MFN 06-191

**Subject: Response to Portion of NRC Request for Additional Information
Letter No. 38 Related to ESBWR Design Certification Application –
Structural Analysis - RAI Numbers 3.8-3, 3.8-6, 3.8-13, 3.8-14, 3.8-18,
3.8-19, 3.8-20, 3.8-23, 3.8-25, 3.8-26, 3.8-27, 3.8-40, 3.8-41, 3.8-46,
3.8-47, 3.8-48, 3.8-49, 3.8-51, 3.8-56, 3.8-63, 3.8-64, 3.8-82, 3.8-83,
3.8-87, 3.8-90, 3.8-91, 3.8-100, 3.8-104, 3.8-105 and 3.8-106**

**Response to Portion of RAI Letter No. 38 Related to ESBWR Design
Certification Application**

Seismic Category I Structures

Figure 3.8-19(1). 3D Model and Boundary Conditions for Transient Thermal Analysis

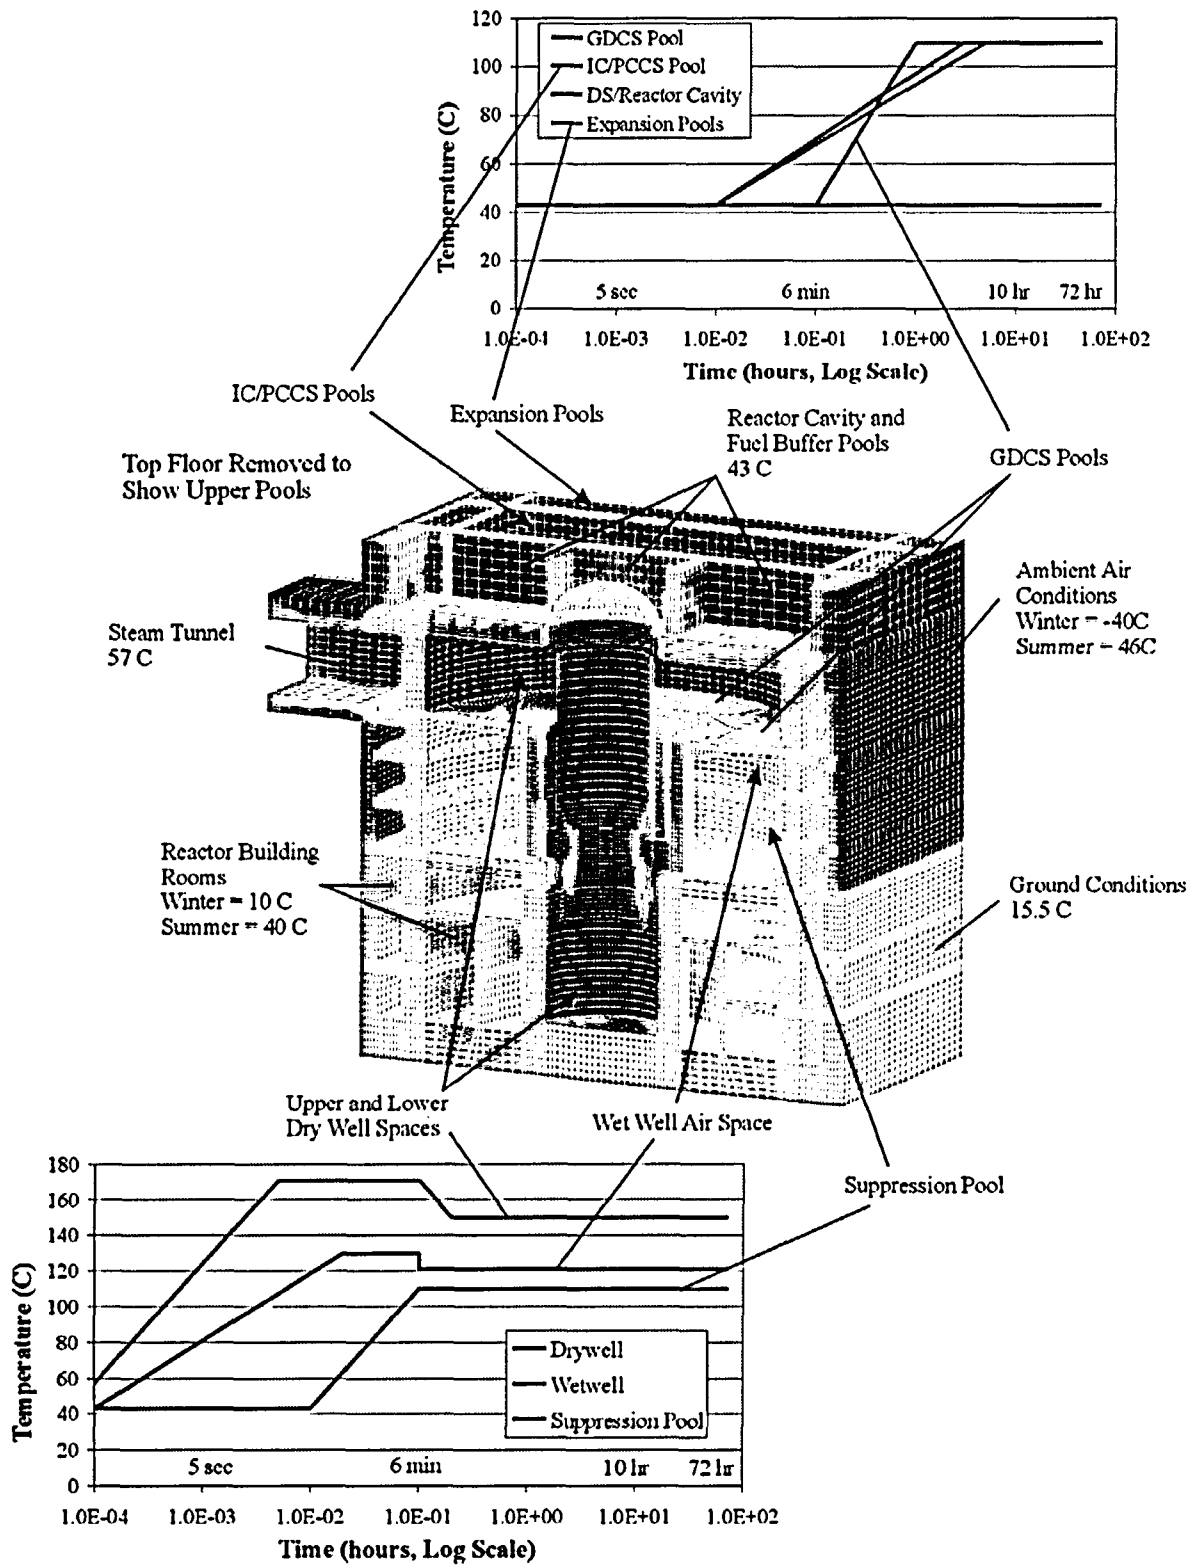
Provide a figure showing the 3-D model (including boundary conditions) used to evaluate concrete cracking under thermal loads, which is discussed in DCD Section 3.8.1.4.1.3. Explain how the approach described in this section, which calculates scale factors of the individual member forces at each critical design-basis section, correctly considers the effect of redistributing the loads due to concrete cracking in the overall containment & building model.

Figure 3.8-19(1) illustrates the 3D model and boundary conditions used in the thermal analyses that define the temperature distributions for the thermal stress and concrete cracking analysis. The model is first initialized for the temperature conditions under normal operating conditions with a steady state thermal analysis, and then a transient thermal analysis is conducted using the boundary conditions and temperature histories representing the design basis accident (or LOCA) shown in the figure. Boundary conditions on exterior surfaces and interior walls exposed to air use a heat transfer coefficient and a reference air temperature. Surfaces in contact with water or the ground use a very large heat transfer coefficient to essentially set the surface temperature to the specified water or ground temperature. Note that analyses are conducted for conditions representing both winter and summer conditions. The stress analyses are then conducted using the 3D ABAQUS/ANACAP model with the temperature distributions from the transient thermal analyses at the specified times of 5 sec, 6 min, 10 hr, and 72 hours. A typical case with time at 6 min. is shown in Figure 3.8-19(2). The stress model is initialized to be stress free at a reference temperature of 15.5 °C (60 °F). This model is used for both a linear stress analysis and a nonlinear concrete cracking analysis for the thermal loads at each of the specified evaluation times. For the nonlinear cracking analyses, the steady state temperature distribution for normal operating conditions is incrementally applied, and then the temperature distributions corresponding to the above evaluation times are incrementally applied allowing concrete cracking and stress redistribution with iterations for static equilibrium.

Figure 3G.1-55. Diaphragm Floor

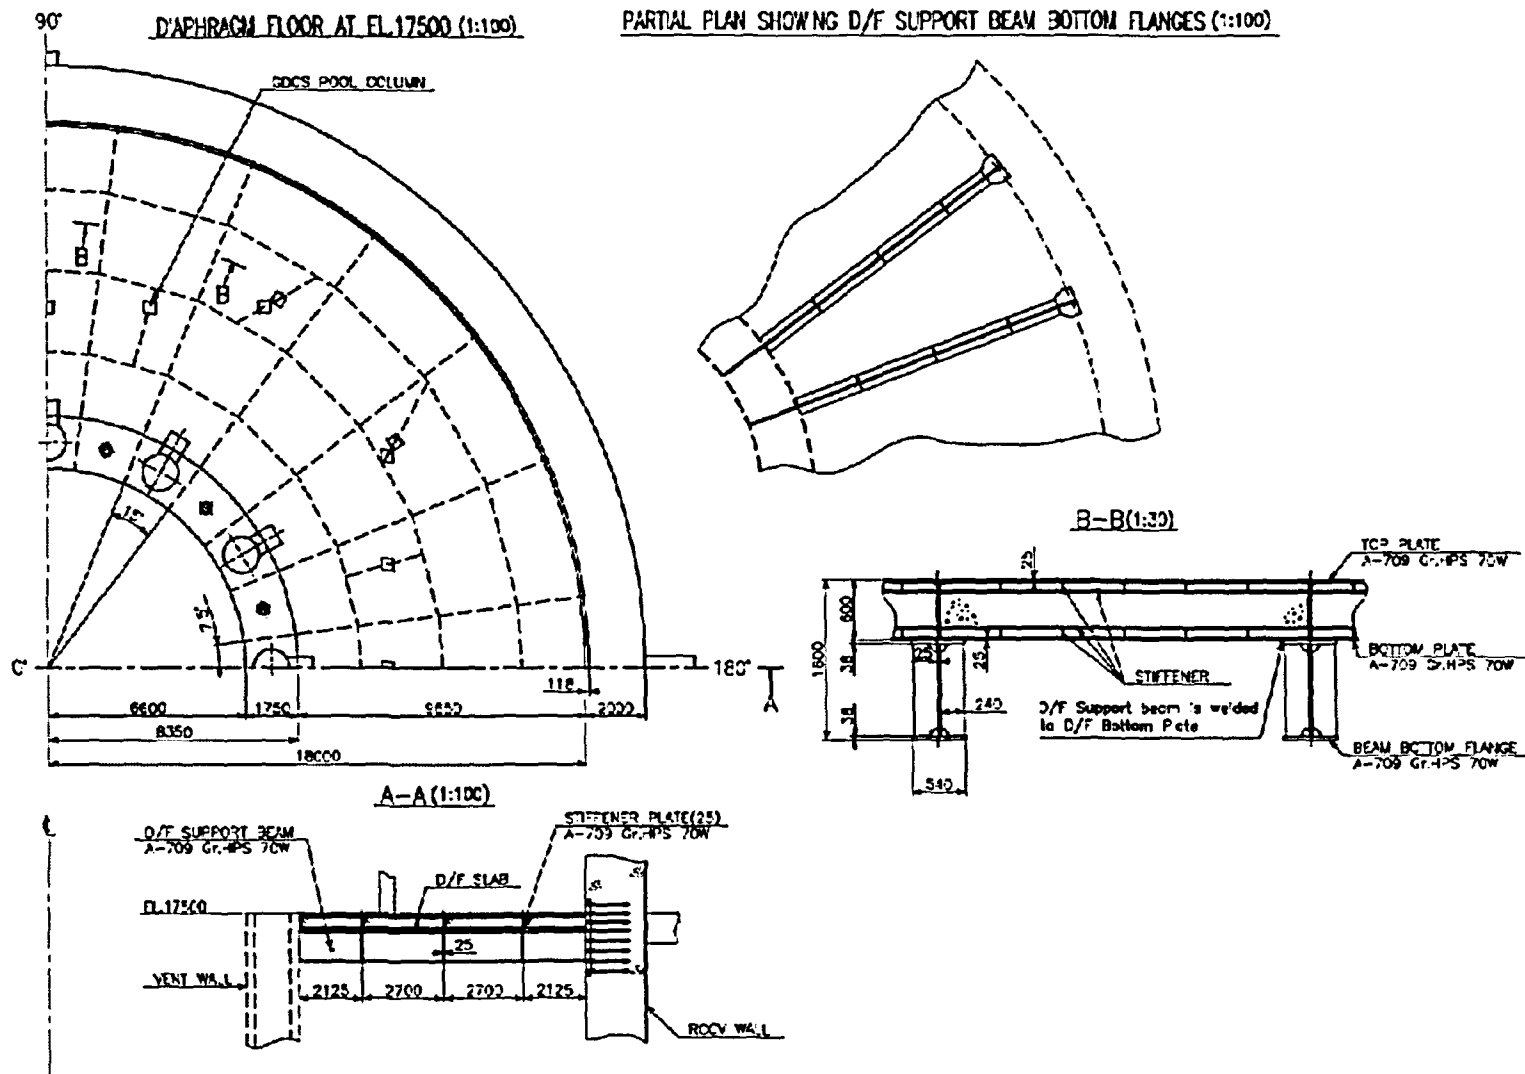
DCD Section 3.8.3.4.1 describes the analysis and design of the diaphragm floor and DCD figure 3G.1-55 provides a drawing of the diaphragm floor. From this information it is not clear whether the diaphragm floor is attached to the radial support beams in a manner that makes them respond as an integral member. Provide a description in DCD Section 3.8.3.4.1 and show in DCD Figure 3g.1-55 how the diaphragm floor and radial support beams are connected.

DCD Section 3.8.3.4.1 and DCD Figure 3G.1-55 will be revised in the next update as noted in the attached markup.
